21/5/19
FLOREA ARD
ARCH.
SECOND FLOOR PLAN

21/5/19
FLOREA A&D
SECOND FLR PLAN

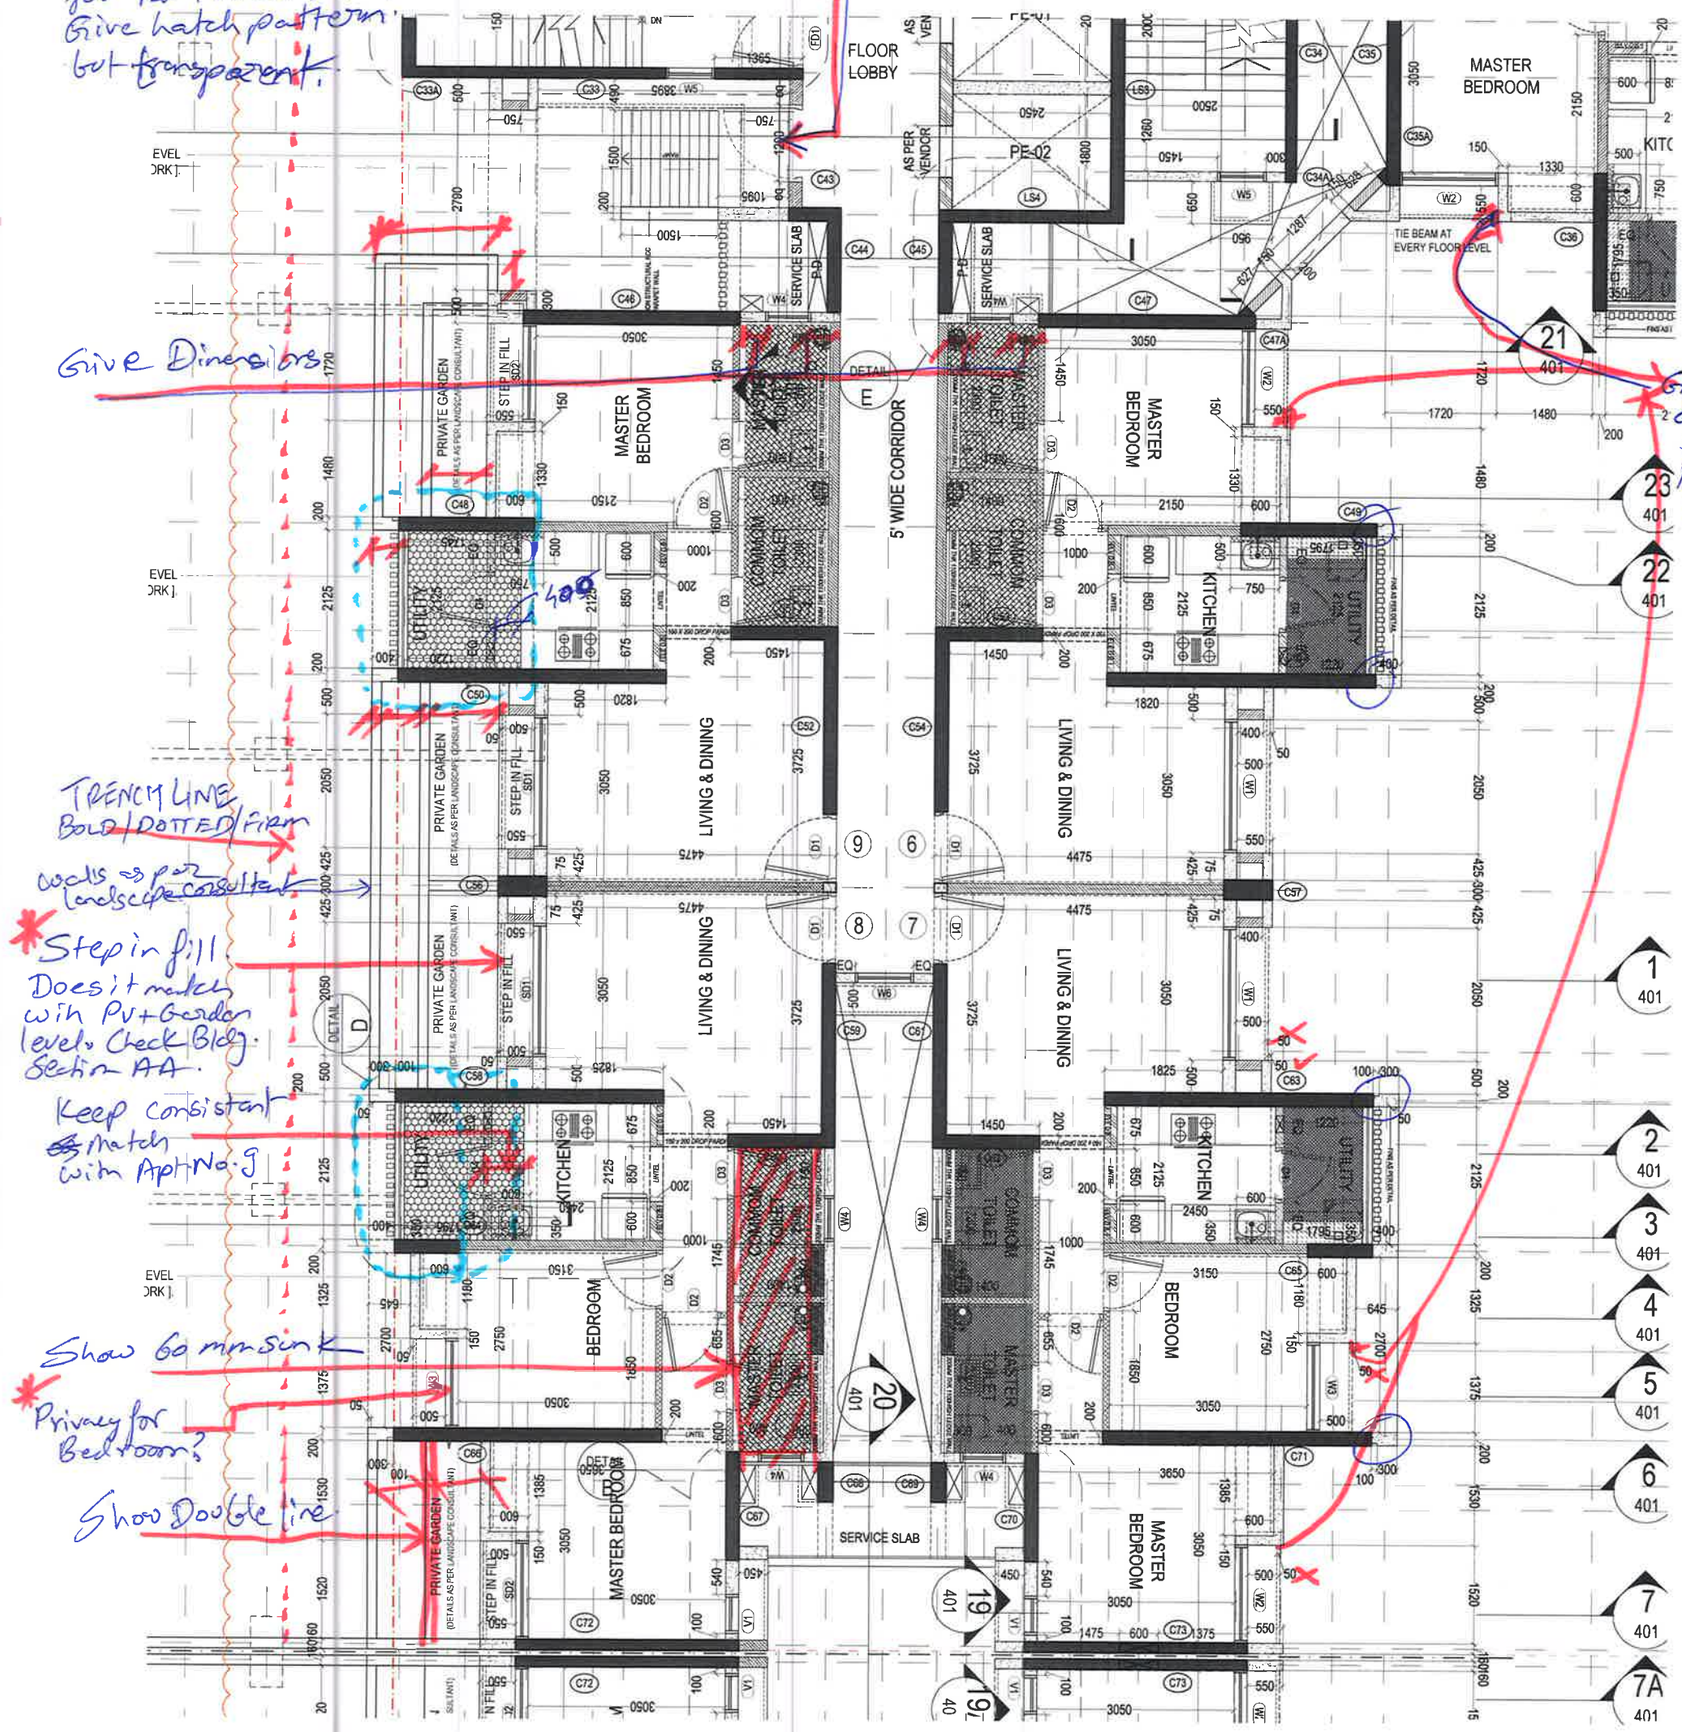
* Remove all dimensions from chajja edge to drip mould.

DOOR NOMENCLATURE?
E03.

* Remove magenta & yellow hatch for ~~P~~ Trench & PVT Garden.
Give hatch pattern but ~~transparent~~.

Give Dimensions

TRENCH LINE
BOLD / DOTTED / FIRM

walls ⇒ for landscape consultant

* Step in fill.
Does it match with PVT+Garden levels. Check Bldg. Section AA.

Keep consistant
~~Match~~
with Apt No. 9

Show 60 mm sink

* Privacy for Bedroom?

Show Double line

Give dim. 50 mm from outside edge

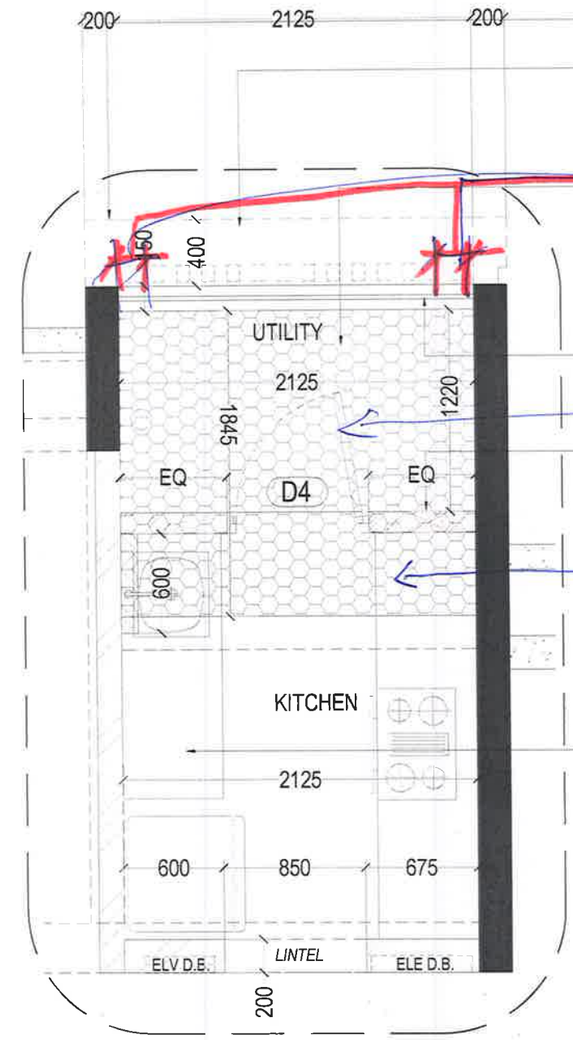
① Remove Blown up detail @ 'C' or else give blown up for 2BHK utility since groove, column & portal conditions are different.
② Vertical groove detail to be labelled & marked in main plan wherever applicable
③ Mark dimensions of Non-struc. wall 300/400 in blown up details A, B, D & E.
④ Give chajja overhang dimensions of staircase windows.
⑤ Section 26 will change - check/Review.

Elevation shows a gap between fins & wall. Is there any wall return to be shown in plan??

Show WASHING machine tap etc.
